Wattle Creek Battery Energy Storage System

SSD-63345458

Landscape & Visual Impact Assessment

Addendum

Figure 01 Viewshed Map for BESS Project
 Basemap Source - Google Earth, 2025

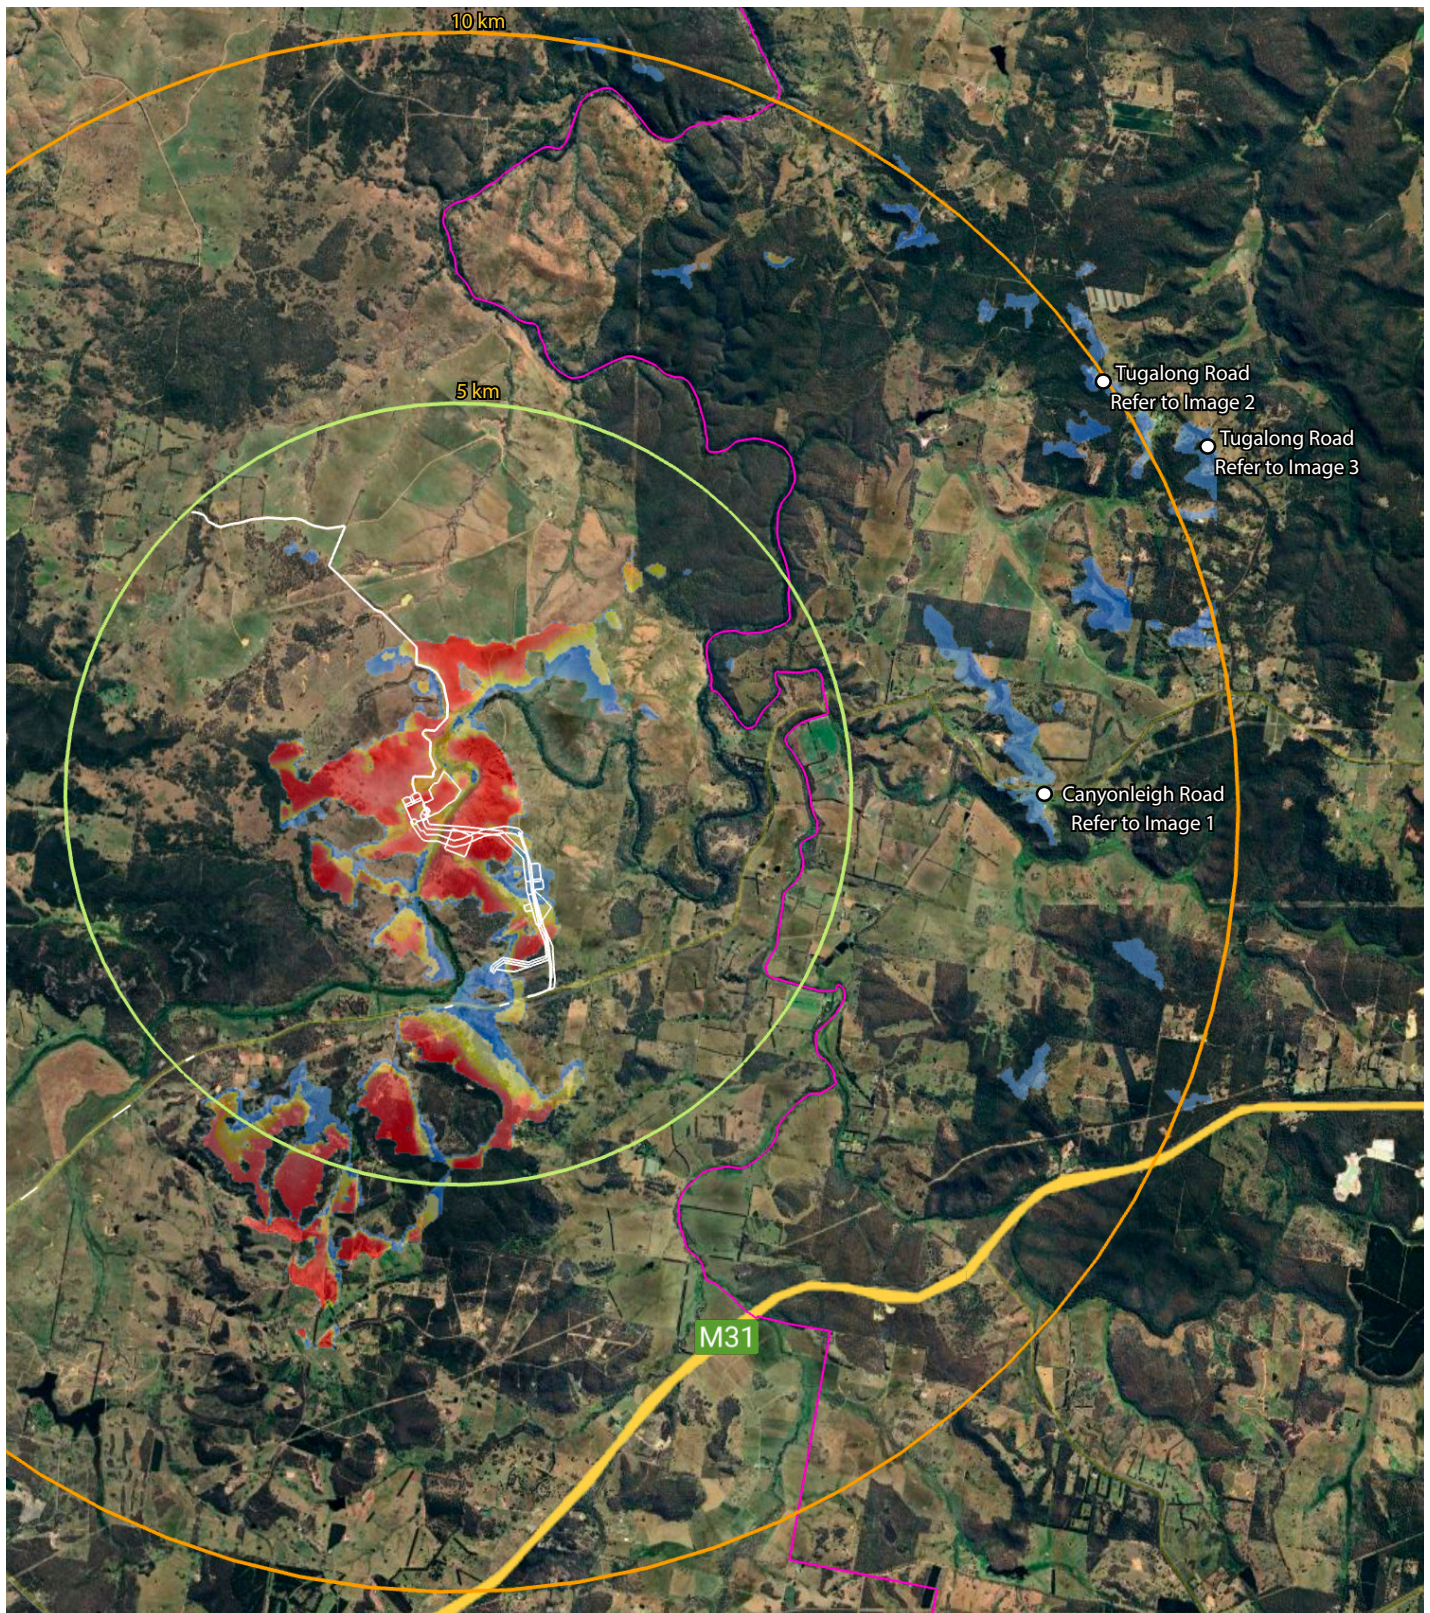
WSC Submission	
1.	Limited Study Area Excludes Elevated Viewpoints in WSC. The Landscape and Visual Impact Assessment (LVIA) restricts its detailed assessment to a 5 km radius from the project boundary. This fails to adequately consider elevated landforms east of the development Site within the WSC, which are capable of experiencing line of sight views over the proposed development from many locations, including: - Canyonleigh - Elevated portions of Tugalong Road - Ridgetop properties adjoining including rural residences with long range western outlooks.

A viewshed map has been prepared that extends beyond 10 km to demonstrate the theoretical line of sight to the Proposed Infrastructure from areas located within the Wingecarribee Shire Council (WSC) Local Government Area (LGA). Refer to **Figure 1**. The viewshed mapping represents a theoretical and deliberately conservative worst-case scenario, identifying potential visibility based on topography alone. The viewshed map does not take into account vegetation and built form and is to be considered a conservative assessment tool utilised to identify areas for further assessment.

The viewshed map demonstrates there are a very small number of areas beyond the 5 km Study Area that have potential line of sight to the Project Area. Where visibility is available, it is limited to less than 25% of the BESS Infrastructure.

Figure 02 Viewshed Map for Canyonleigh

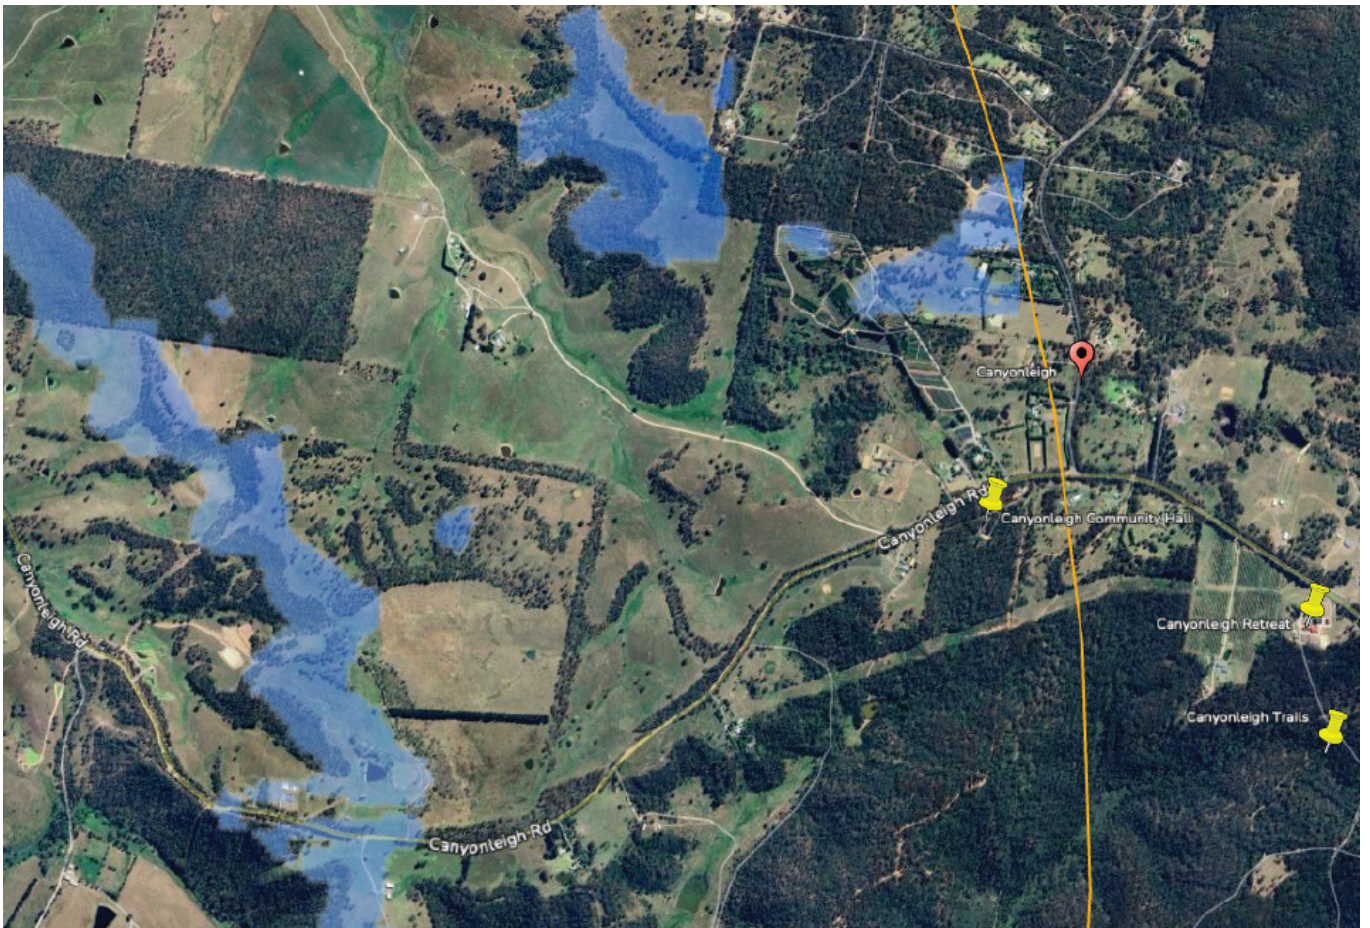
Location identified by WSC:	Response
Canyonleigh	Moir have undertaken an assessment of the visibility from Canyonleigh using viewshed mapping. Canyonleigh is located approximately 10 kilometres from the Project. There are limited opportunities for a theoretical line of sight to the Project Infrastructure from key viewpoints in Canyonleigh (ie. Community Hall, Canyonleigh Retreat and Canoyneigh Trails). A small section of Canyonleigh Road was identified as having the potential for theoretical visibility to the Project Infrastructure. Further analysis indicates there is dense roadside vegetation that would prevent visibility to the Project Infrastructure from this section of road. Refer to Figure 2 and Image 1 .

Figure 03 Viewshed Map for Tugalong Road

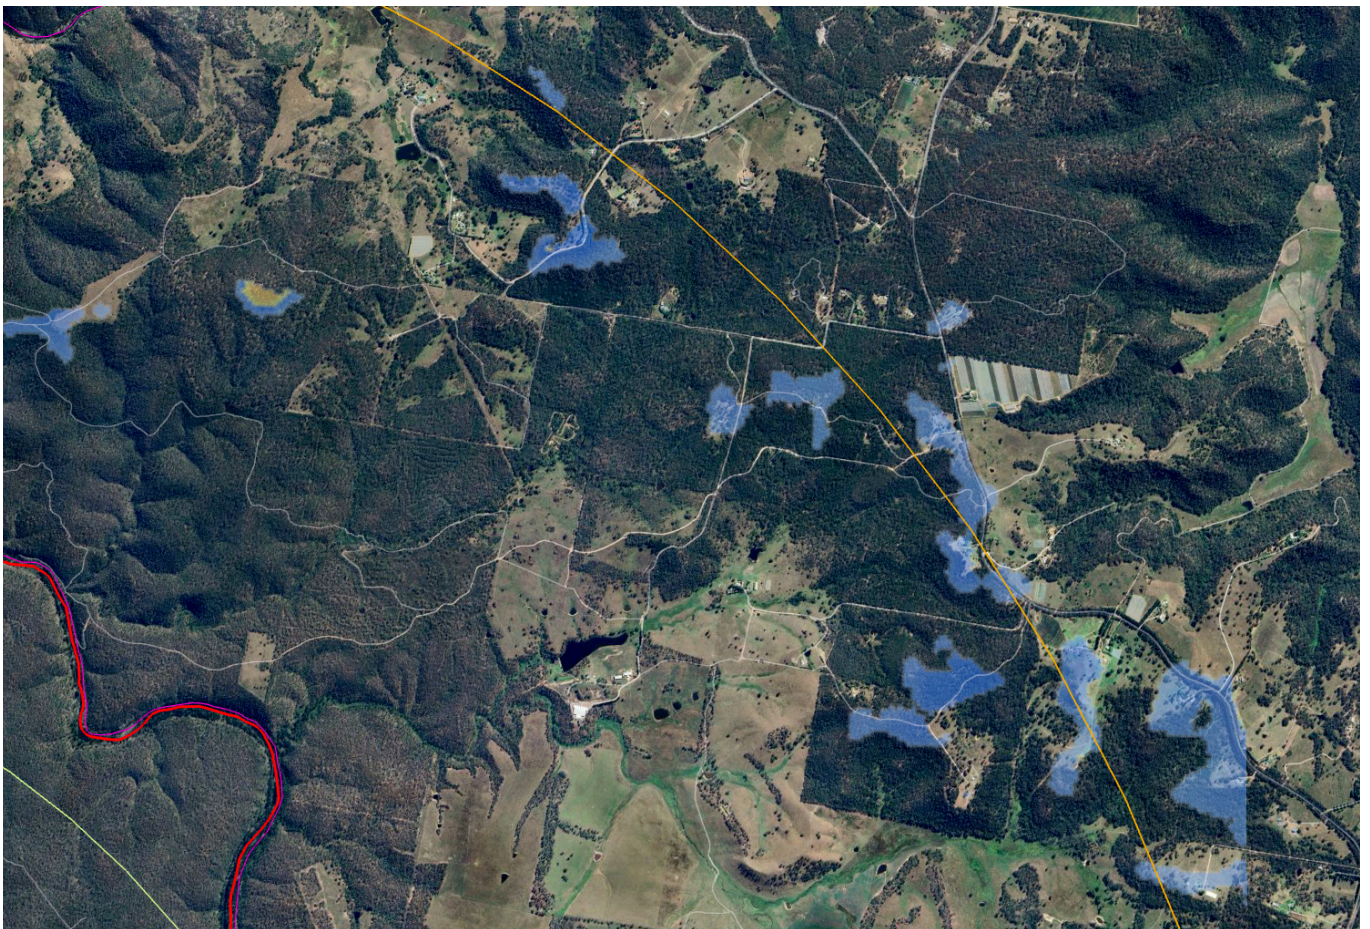
- Elevation portions of Tugalong Road - Properties in Tugalong - Ridgetop properties adjoining including rural residences with long range western outlooks	Viewshed mapping prepared for the Project indicates that there is limited potential for visibility of the Project Infrastructure from Tugalong Road and the associated properties in the Tugalong Road vicinity. Where there are opportunities for a theoretical line of sight to the Project, Moir have undertaken further analysis. It is determined that dense roadside vegetation that characterises the landscape prevents views to the Project from Tugalong Road. Refer to Figure 3, Images 2 & 3. The viewshed map indicates potential visibility to the Project Infrastructure from small pockets of land associated with the ridgeline. Where these areas have been identified, vegetation typical of the area is likely to reduce visibility. Where views are available, views to the Project would be distant and the visual impact would be negligible.

Figure 04 Revised Transmission Line Route

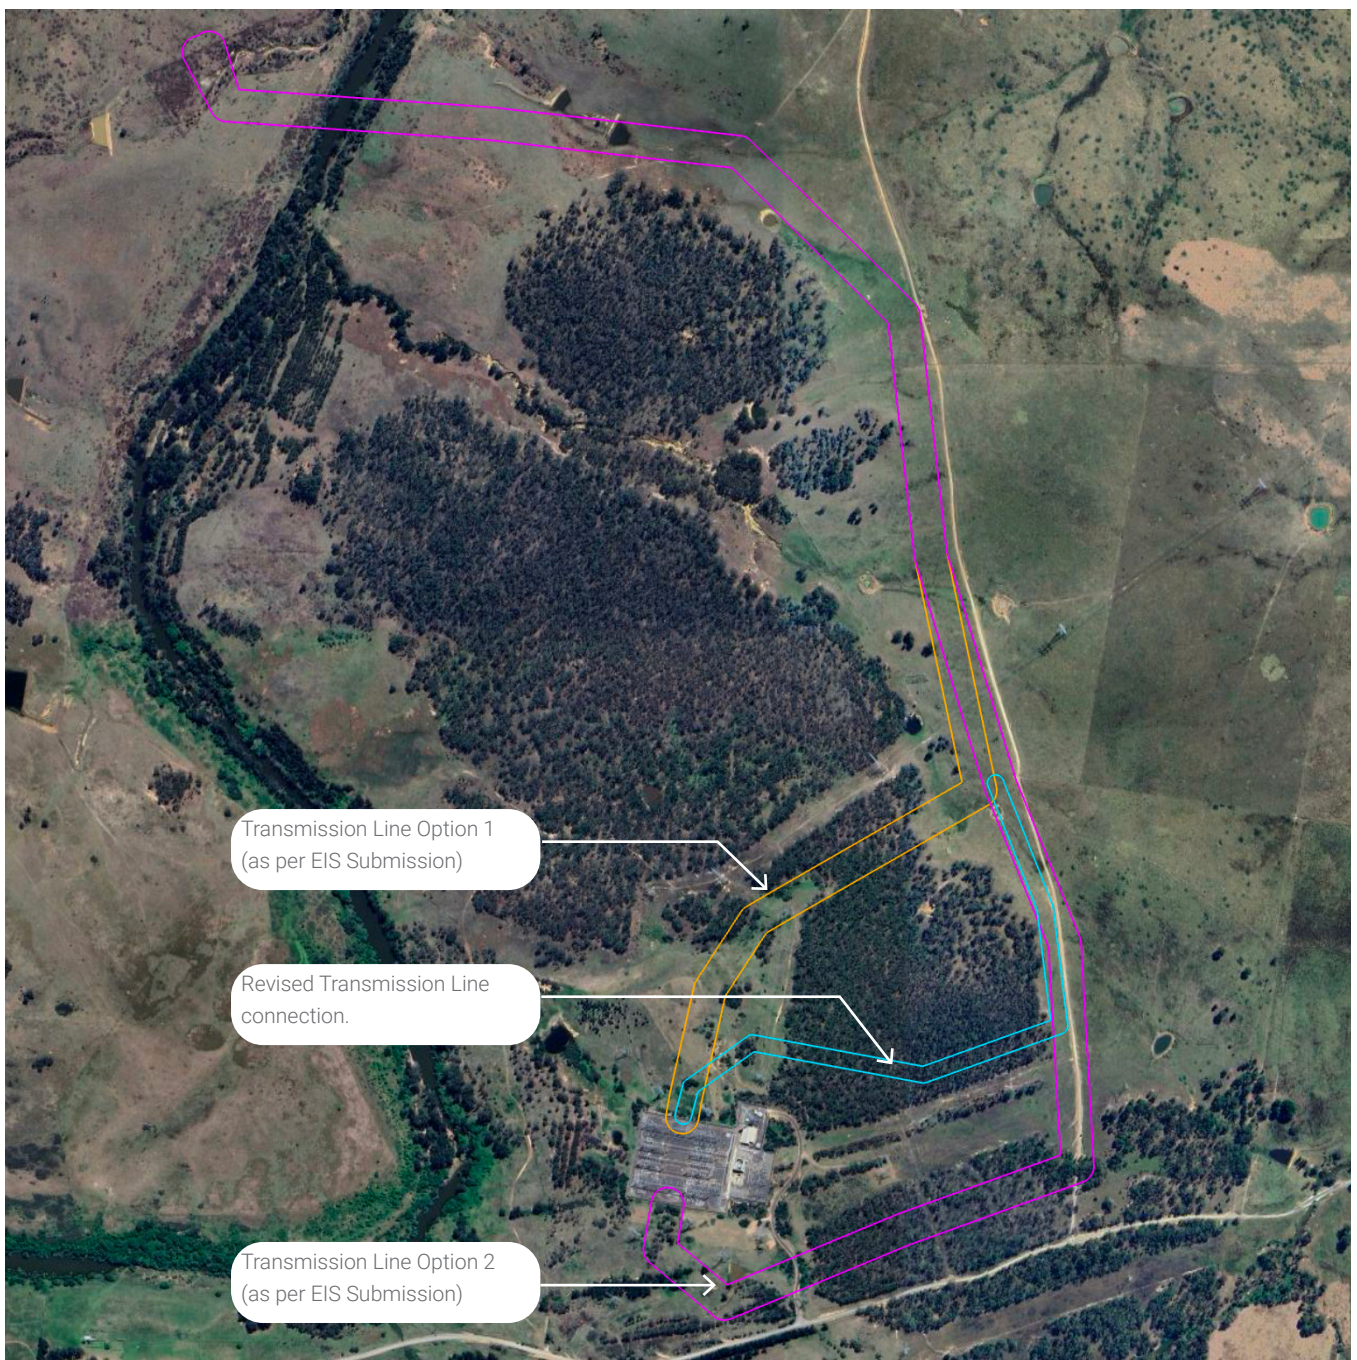
The LVIA prepared for the EIS submission identified two route options that were assessed for optionality. The transmission line consists of up to 7 km of internal overhead cables from the BESS to the grid connection point. Since the lodgement of the EIS, a final route layout has been proposed that is located between the two route options assessed in the EIS (see Figure 4). As this third option sits within the envelope of the previously assessed routes, it does not result in any change to the outcomes of the assessment.

Figure 05 Viewshed of Telecommunications Mast

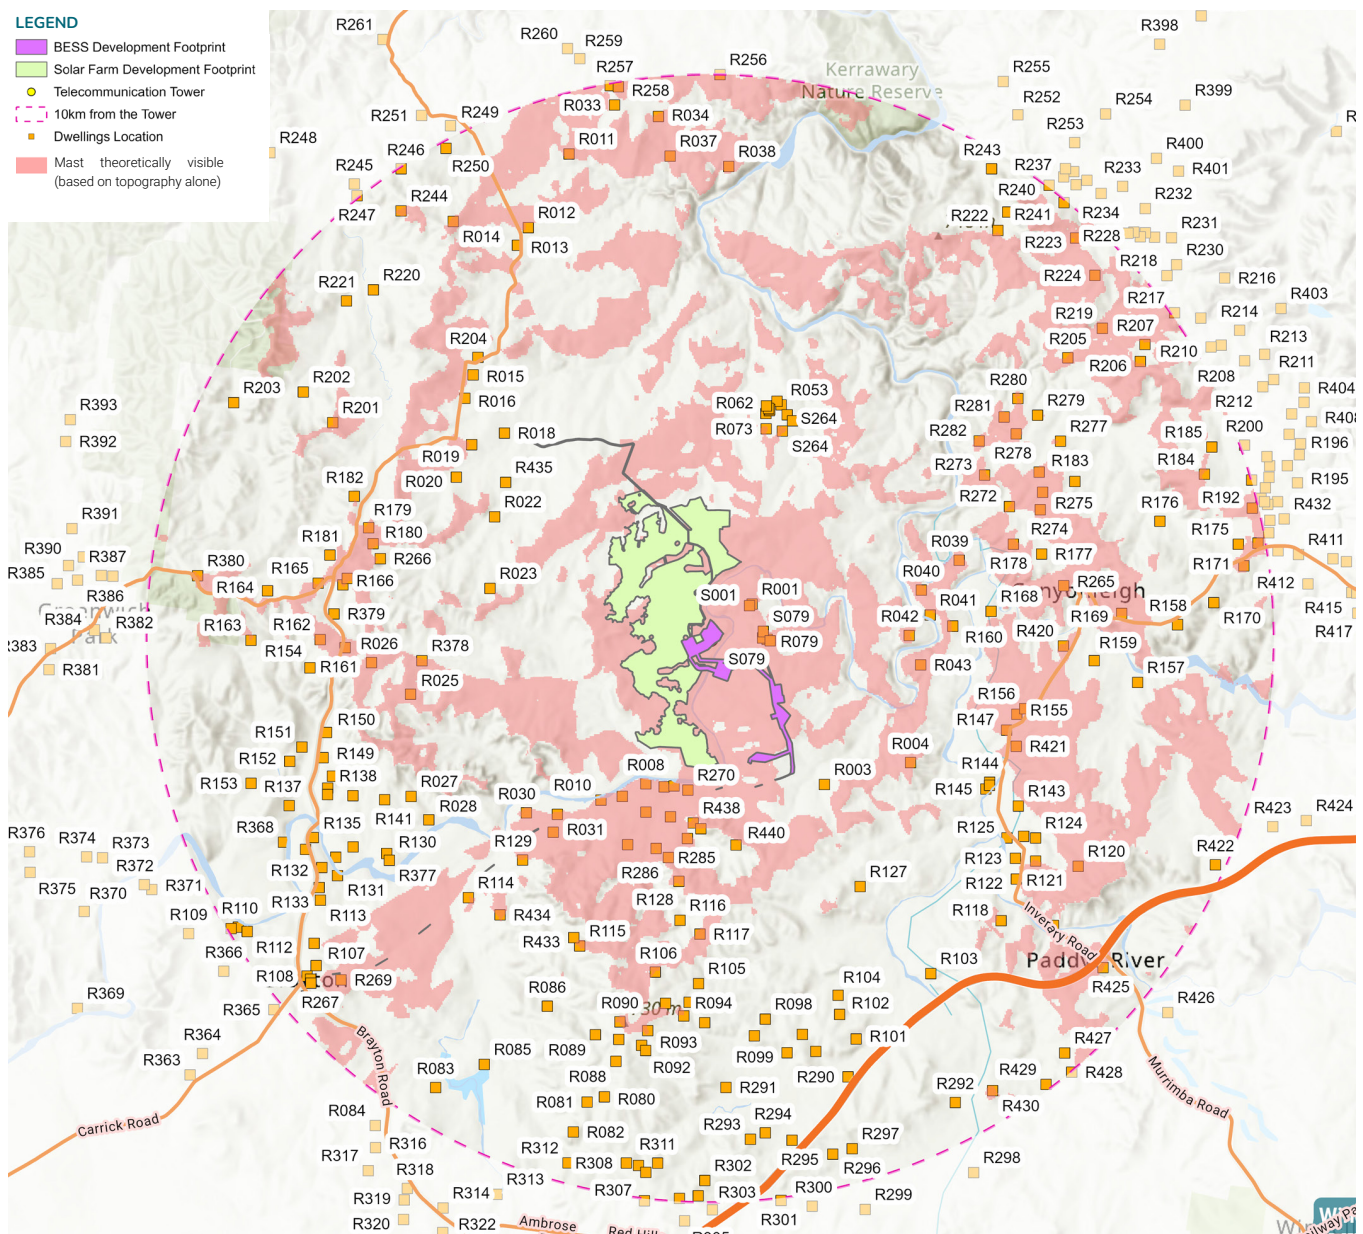
A Telecommunications Mast (Mast) is proposed at the substation site. The Mast is proposed at a maximum height of 80 metres. A viewshed map has been prepared to illustrate areas from which the mast has the potential to be theoretically visible (based on topography alone). Due to the vertical scale of the Mast the viewshed map identifies opportunities for views of the Mast from surrounding public viewpoints, however in reality, opportunities will be limited due to existing intervening vegetation which is typical of the area.

Although there are potential opportunities to view the Mast, it has been designed as a thin, lightweight structure, minimising bulk and reducing overall visibility within the surrounding landscape. Due to the slender and design, it will be difficult to discern. The appearance of the Mast is consistent with existing utility structures existing in the area and will result in a negligible visual impact.
